Docket:  
Exhibit Number : R.11-02-019  
Commissioner : DRA-04  
ALJ : Florio  
Witness : Bushey  
          : Rondinone

**DIVISION OF RATEPAYER ADVOCATES  
CALIFORNIA PUBLIC UTILITIES COMMISSION**

**DRA REPORT ON THE  
PIPELINE SAFETY ENHANCEMENT PLAN OF  
PACIFIC GAS AND ELECTRIC COMPANY**

Implementation Plan Analysis and Recommendations

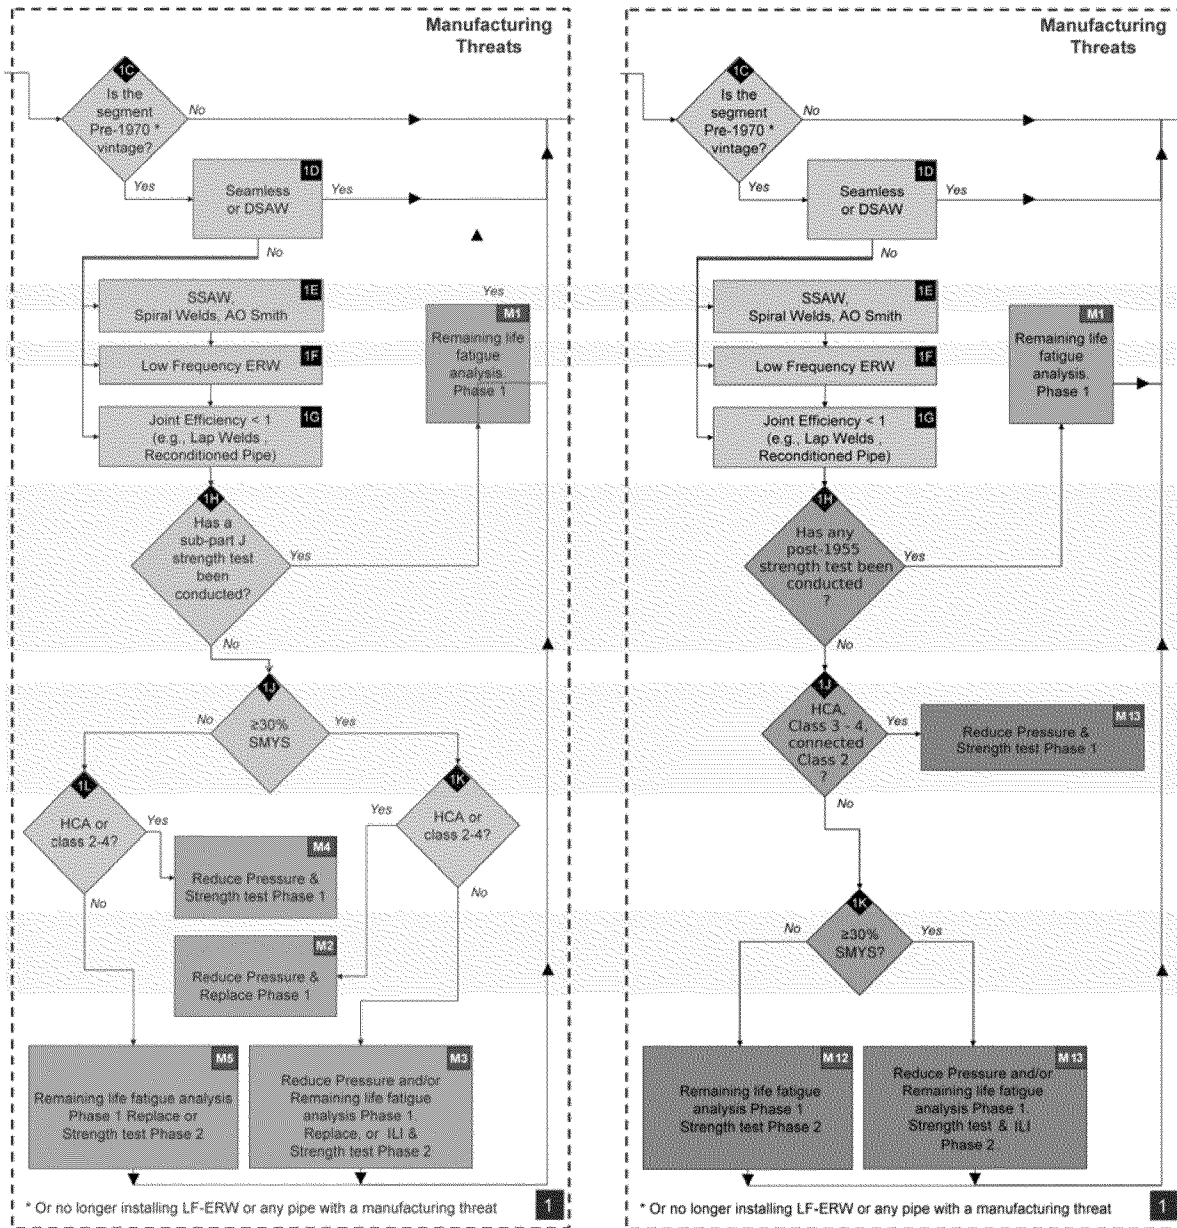
6 The PG&E Decision Tree was found to require adjustments that address pipeline  
7 safety and segment priority. BEAR recommends the following adjustments:

8 Subpart J testing was incorrectly used to evaluate potential pipe joint fabrication  
9 threats. Because documentation of a Subpart J test should not be a deciding point for  
10 taking action on a fabrication or construction threat, BEAR recommends to remove  
11 Subpart J testing as a decision criteria from the Fabrication and Construction portion, part  
12 2, portion of the Decision Tree.

13 BEAR recommends that, with the exception of fabrication and construction threats  
14 (joints between segments), the first action to mitigate risk should be a Subpart J test, in-  
15 line inspection (ILI), and/or a remaining life fatigue analysis.

16 Not all Class 2 areas should be treated with equally high priority as HCA or Class  
17 3 and 4 areas, as is the case in PG&E's original Decision Tree. Instead, BEAR  
18 recommends that only Class 2 segments that are adjacent to or contiguous with Class 3  
19 segments should receive such treatment.

Figure 1a: Decision Tree Comparison – Manufacturing Threats

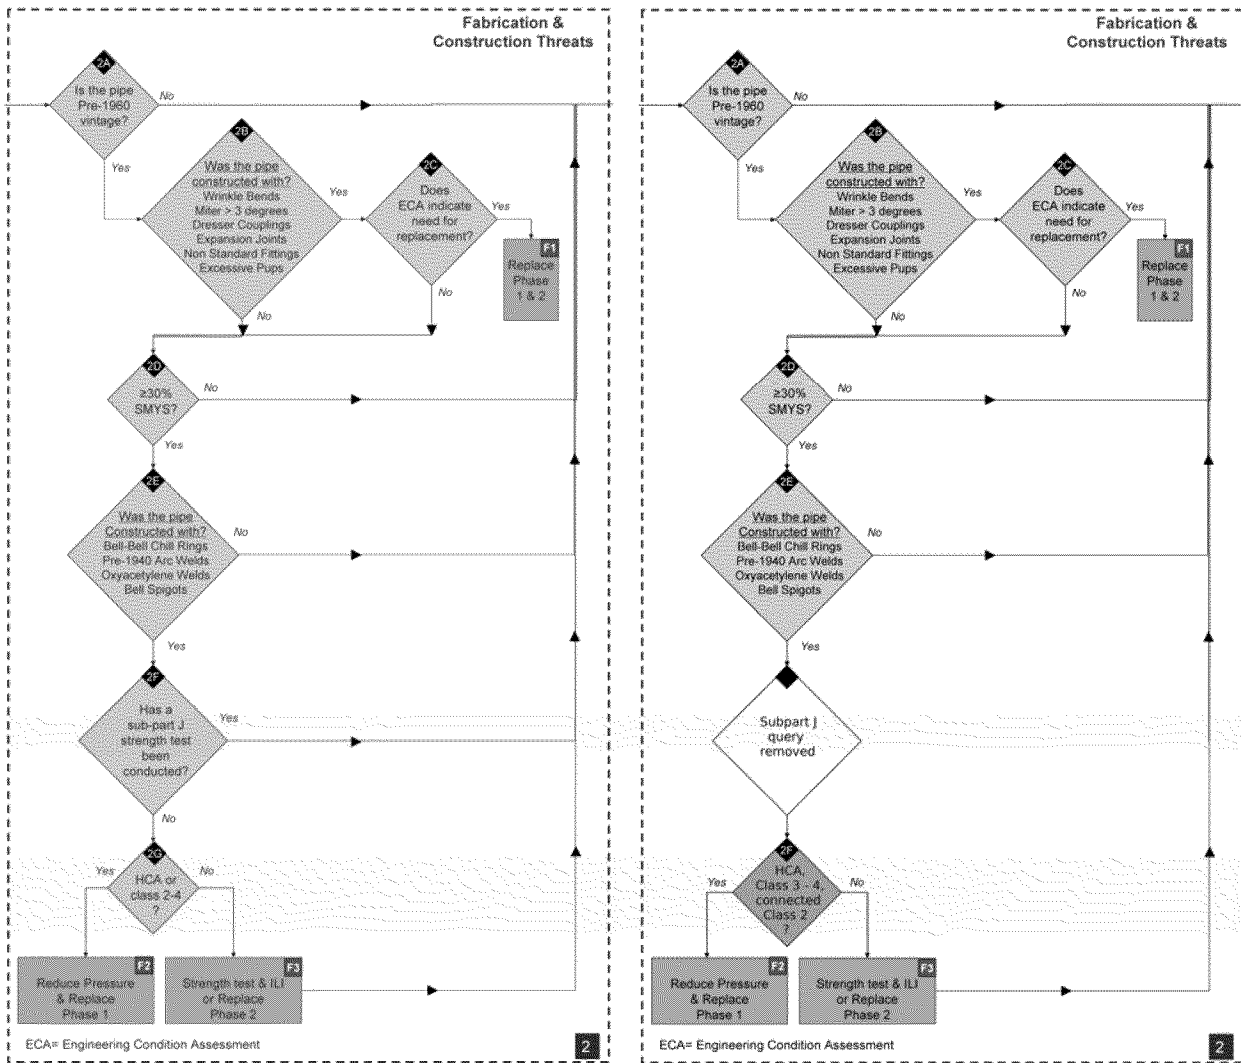
2           In addition to the above classification prioritization, additional improvement in  
3 Phase 1 prioritization comes from two other modifications within the Manufacturing  
4 Threats branch. First is a greater reliance on fatigue analysis and second is using a wider  
5 range of strength tests as input into the fatigue analysis.

6           Rather than query whether a Subpart J test has been conducted (at 1H,  
7 Manufacturing Threats), the query should include any post-1955 strength test, which was  
8 when the ASA B31.1.8 standard included test pressures based on population density. The  
9 strength test results and pressure history can be put to immediate use in a fatigue analysis,  
10 the results of which would guide further action. By doing so, Phase 1 strength testing  
11 will focus on pipes with almost a completely unknown potential for flaw size. Phase 2  
12 will address updating all tests to Subpart J standards.

13           In addition, it should also be noted that replacement as a default Phase 1 action has  
14 been removed from the Manufacturing Threats branch. Replacement may still occur as  
15 the result of a strength test, fatigue analysis, or a Phase 2 decision. With these  
16 modifications, manufacturing threats will lead to a Phase 1 strength test if the pipe  
17 segment has no post-1955 test results and is in a HCA, Class 3-4, or connected Class 2  
18 area.

Figure 1b: Decision Tree Comparison – Fabrication Threats

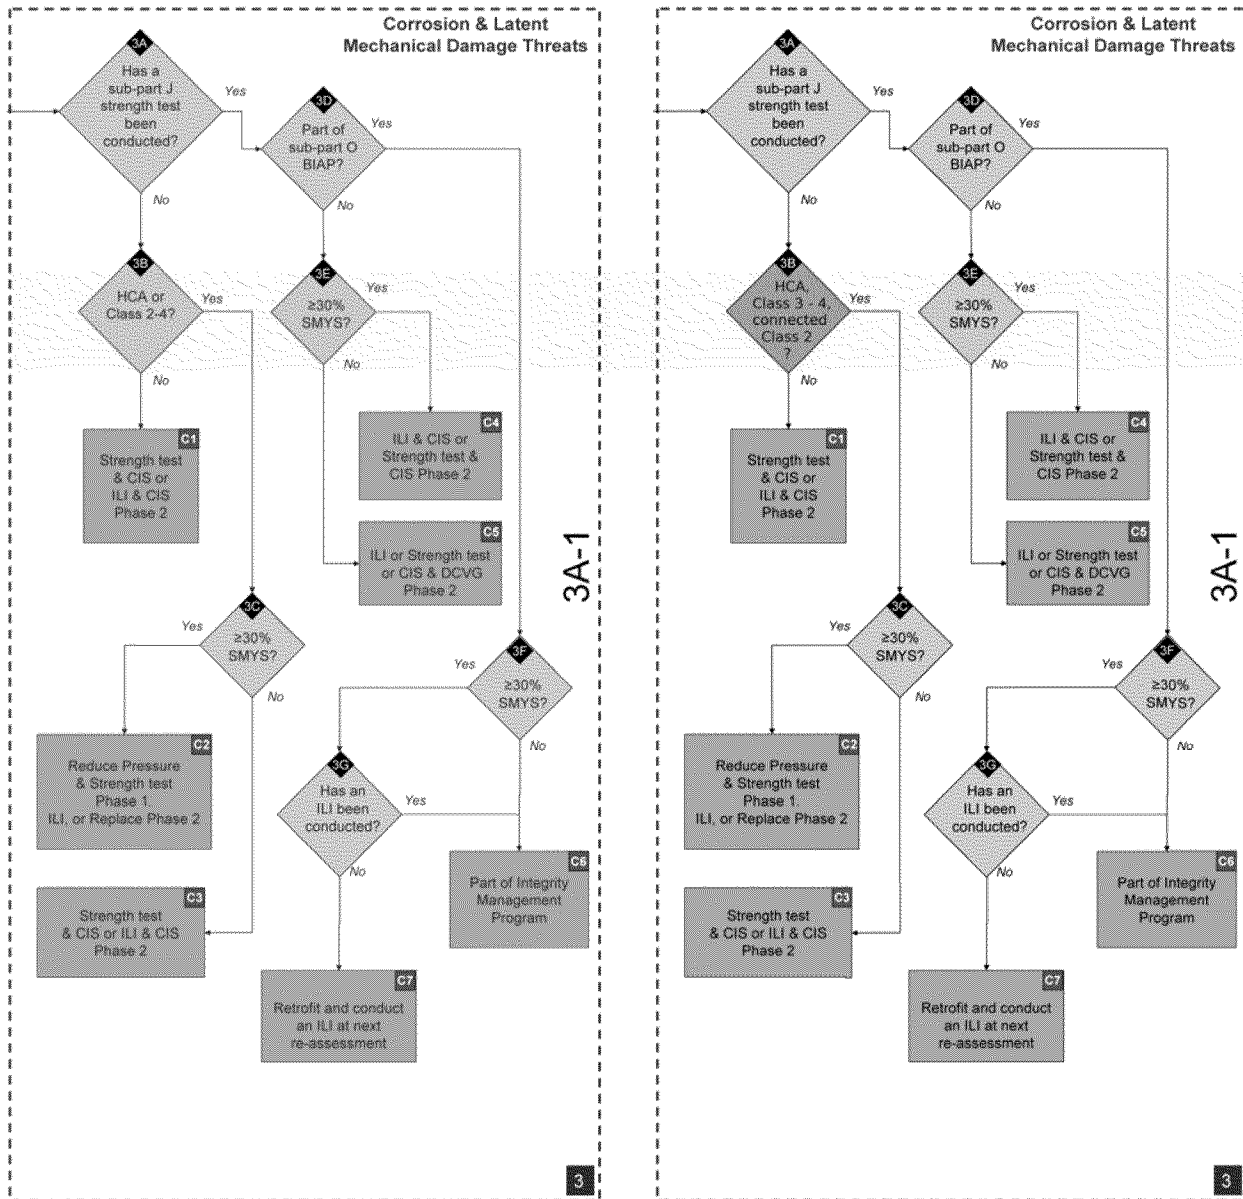
3           Two queries in the Fabrication & Construction Threats branch raise concern. First  
4 is query 2C, which asks if an Engineering Condition Assessment (ECA) indicates a need  
5 for replacement. Details of what this assessment includes were not available, except that  
6 “Any feature whose condition is not proven satisfactory for service or would jeopardize  
7 the success of a subsequent In-Line Inspection will be removed from service”<sup>17</sup>. PG&E  
8 verbally confirmed that the ECA had not yet been formulated<sup>18</sup>. Until that time, BEAR  
9 recommends that an assessment include the potential for soil movement (seismic or  
10 otherwise).

11           Next is the use of a Subpart J query at 2F. BEAR is in agreement with Kiefner &  
12 Associates, Inc that the pipe features listed in the Fabrication & Construction Threats  
13 branch are primarily susceptible to failure from axial rather than hoop stresses<sup>19</sup>.  
14 Consequently, a hydrostatic test is not well suited for evaluating the condition of these  
15 features. For this reason, BEAR recommends removing this Subpart J query.

16           This modification presents a lower risk than the original Decision Tree. More  
17 segments will be flagged for Phase 1 replacement than in the original Decision Tree, and  
18 all of these additional segments will be in high priority areas. It should be noted that  
19 action F3 still includes a strength test, but it is the ILI that is most important.
